Our ref.: NPC19001 C51 obsolescence

Subject: Notification of Change

Incremental encoder C51

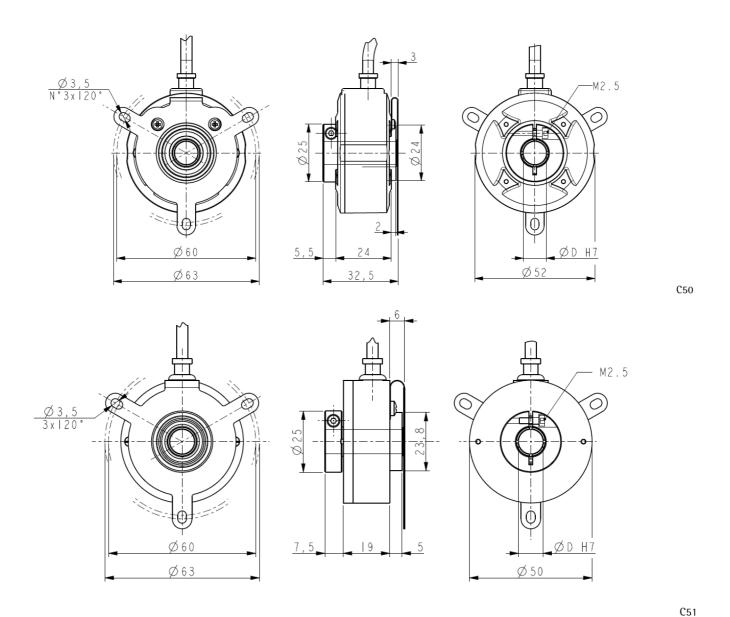
Obsolescence of the product.

The complete range of C51 encoders will be replaced by an equivalent version of the C50 series. The C50 series has same or better technical specifications and can therefore be used to fully replace the C51.

All resolutions previously available only for C51 will be added to the C50 series.

Comparation table / list of differences		
Series	C50	C51
Picture		
Housing material	Die cast Zamac	Anticorodal aluminium
Dimensions	Housing diameter Ø52mm Total length 32.5 mm No change in fixing method. (see drawings)	Housing diameter Ø50mm Total length 31.5 mm
Resolution (PPR)	6, 10, 12, 25, 40, 50 100, 180, 200, 256, 300, 360, 400, 400, 512, 600, 1000, 1024, 1500, 2000, 2048, 2500, 4000, 4096, 8192	6, 10, 12, 25, 40, 50, 1500
Avantages of C50	more competitive pricebroader range of resolutions availablemore fixing plateshigher production volume
